Model: AT-C3	Date: 15-Feb-12	No.: RD142001a
--------------	-----------------	----------------

Subject: Firmware Release Note: PowerSaving Sys		Prepared by: S. Hayami	
From: 1st Tech Service Sect., MFP/Printer Tech Service Dept.			
Classification:	<input type="checkbox"/> Troubleshooting <input type="checkbox"/> Mechanical <input type="checkbox"/> Paper path <input type="checkbox"/> Product Safety	<input type="checkbox"/> Part information <input type="checkbox"/> Electrical <input type="checkbox"/> Transmit/receive <input checked="" type="checkbox"/> Other (Firmware)	<input type="checkbox"/> Action required <input type="checkbox"/> Service manual revision <input type="checkbox"/> Retrofit information <input checked="" type="checkbox"/> Tier 2

This RTB has been issued to announce the firmware release information for the **PowerSaving Sys.**

Service Manual Correction: Main chapters

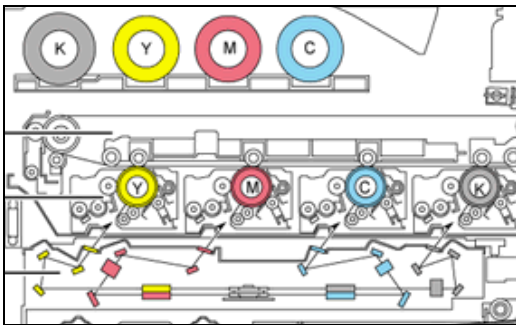
Page	Contents
p.24 p.26	Change: Wrong order of toner bottles and PCUs in the illustration. To: 
p.32	Change: Option name and the code. Copy Data Security Unit Type F: B829 To: Copy Data Security Unit Type G: D640-41
p.118	Change: Accessory Check Lower Output tray – Qty: 2 To: Lower Output tray – Qty: 1

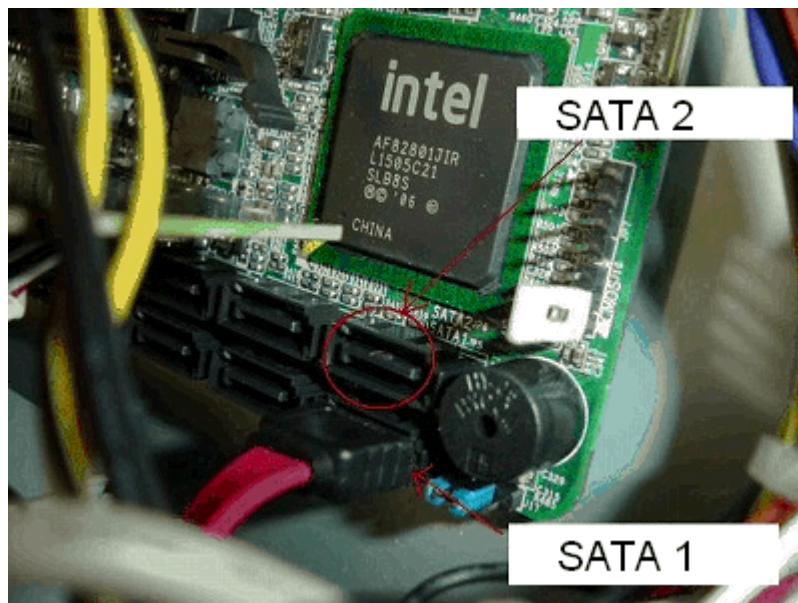
The HDD cable is mistakenly connected to the SATA 2 port, instead of the correct SATA 1 port.

3. Remove the HDD cable connector from SATA 2, and then reconnect it to **SATA 1**.

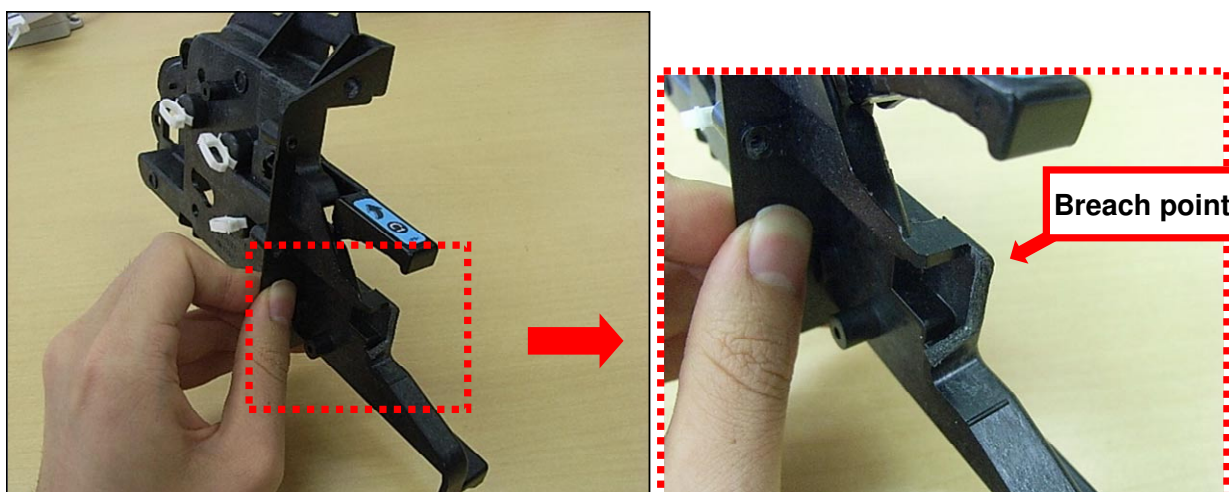
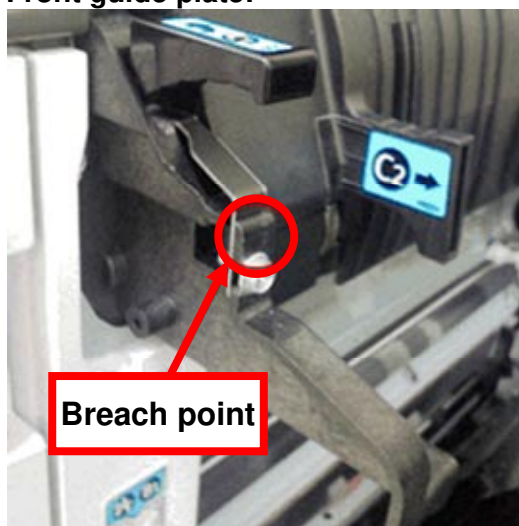
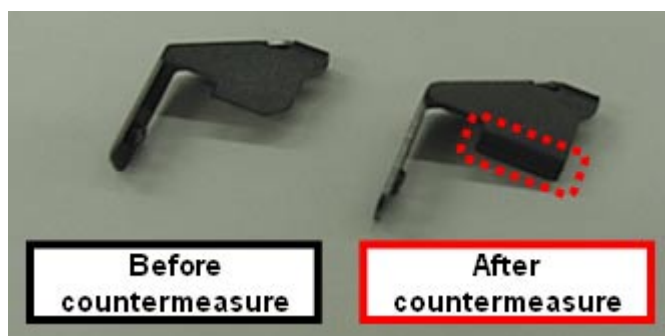
The front stopper and/or front guide plate of the fusing unit are damaged when the customer pulls the fusing unit out.

The user pulls out the unit with force, breaking the stopper that supports the unit, and in some cases, the front guide plate as well.

Replace the stopper with the new-shaped one.

Also if the guide plate is damaged, replace the guide plate and the duct seal attached to the guide plate. Then, remove the lever lock [A] and all clamps from the old guide plate and use them to attach the new one.

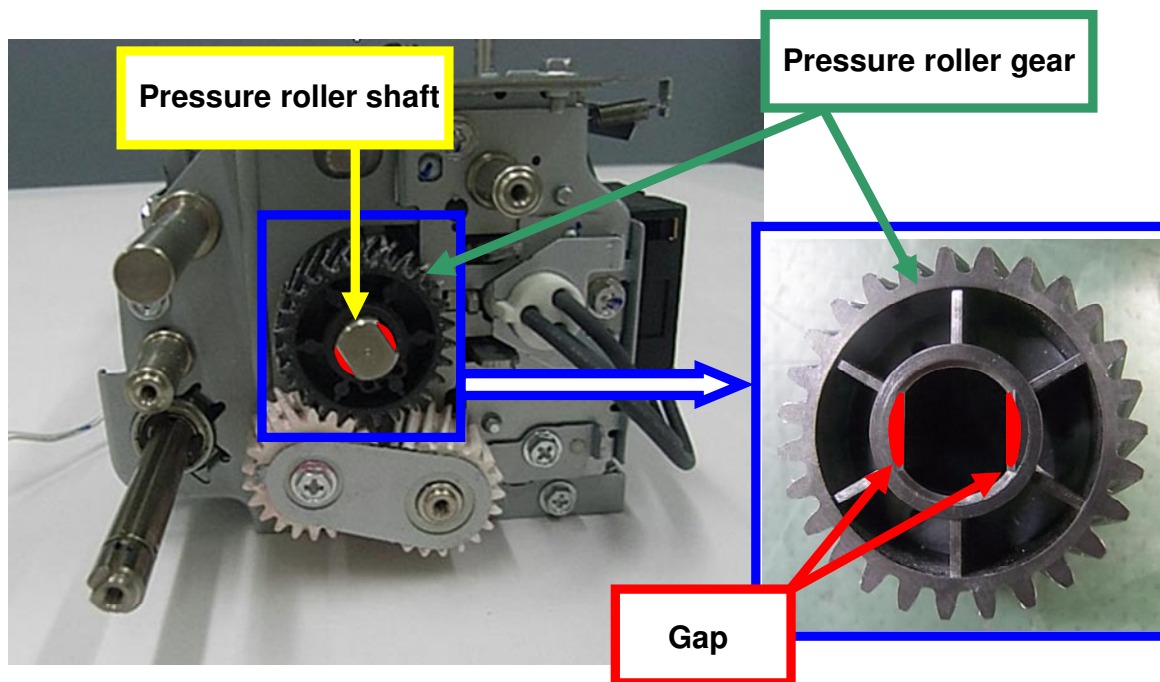
Gaps between the pressure roller gear and pressure roller shaft (marked in red below) may allow the shaft to slip inside the gear opening.

Replace the pressure roller gear with the modified one.

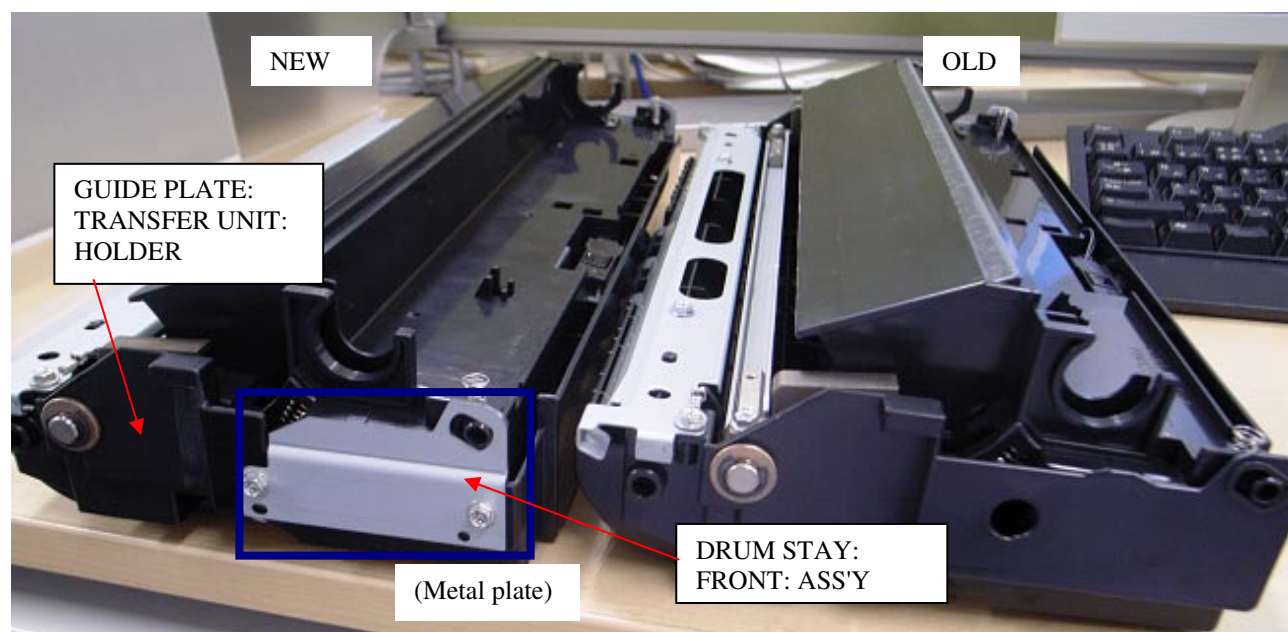
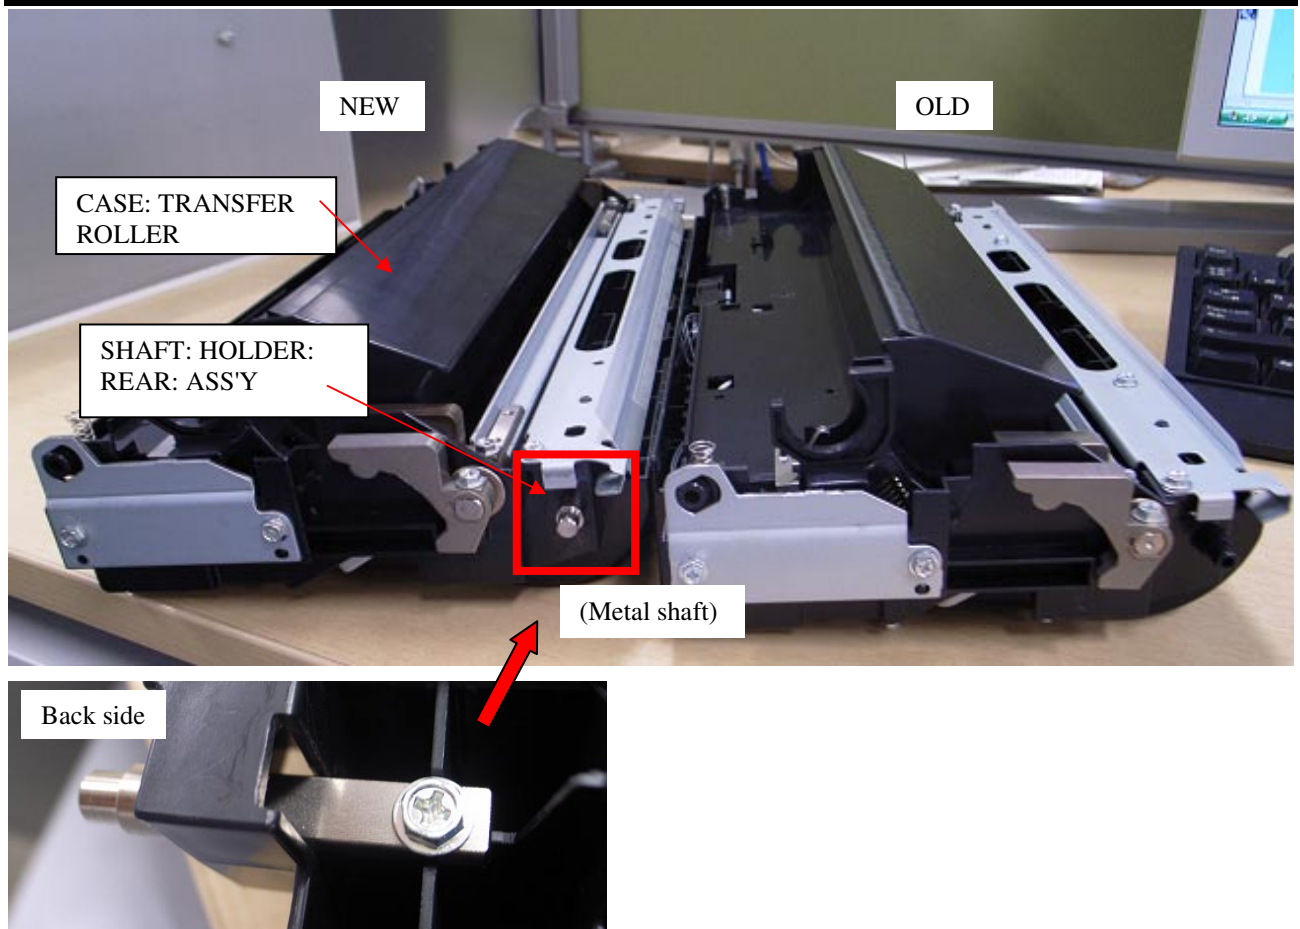
Change: The material of the parts was changed from a resin to a metal.

Reason: To further increase the load-bearing strength of the parts.

Important: Interchangeability is **X/O as a set** (all six parts together).

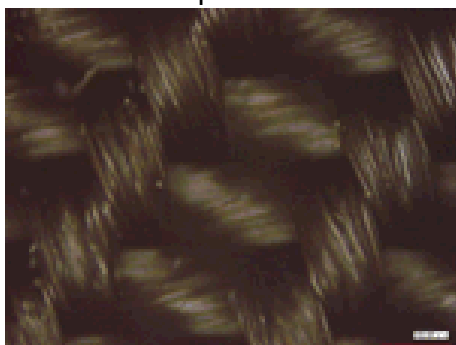
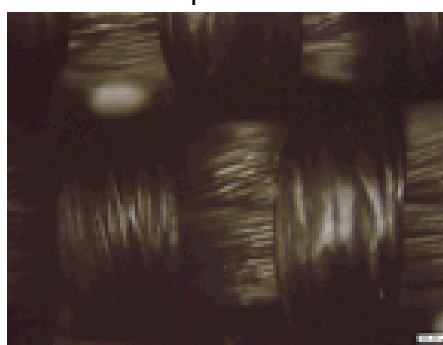
The net for the fusing pad was changed so that it retains more oil and can apply the right amount of oil to the pad. This will increase the durability of the fusing sleeve.
